Consideration of BLER method using PMA measurements

Related to comment #307 against D2.2

Xuebo Wang, Guangcan Mi (Huawei)

174A.9.6 BLER method for all lanes using PMA measurements

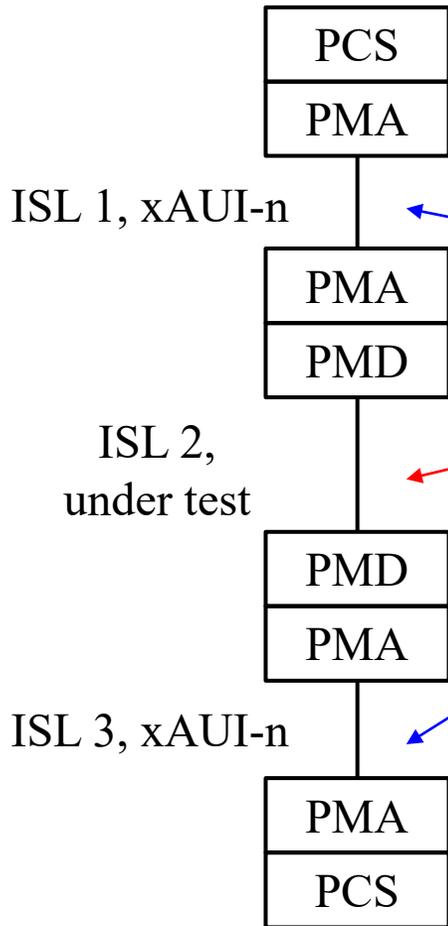
| Cl | 174A | SC | 174A.9.6 | P | 748 | L | 12 | # | 307 |
|--------------|----------|----------------|----------|---|-----|---|----|---|--|
| | | | | | | | | | When using Equation (174A-5) to calculate $H_a(k)$, the value of p should be specified to be 1 as $H_a(k)$ is a theoretical histogram without per-lane simulation. $H_a(k)$ should reflect the error distribution over all lanes of an AUI. |
| | | | | | | | | | Change the sentence "Calculate the error histogram $H_a(k)$ for the added BER using Equation (174A-5) with $BER = BER_{\text{added}}$." to "Calculate the error histogram $H_a(k)$ for the added BER using Equation (174A-5) with $BER = BER_{\text{added}}$ and $p = 1$." Do the same change for Line 33 on Page 748 and Line 10 on Page 751. |

| Cl | 174A | SC | 174A.9.6 | P | 748 | L | 12 | # | 307 |
|--------------|----------|----------------|----------|---|-----|---|----|---|--|
| | | | | | | | | | REJECT. The current method uses a value of p based on the number of lanes in on the interface. In a real application only a $1/p$ portion of each RS-FEC codeword would appear on each lane. This test method as currently written reflects this reality. Although might be the case that simplifying this approach by setting p to 1 universally would yield the same result, no evidence to this effect has been provided. Evidence to support the proposed change is required. |
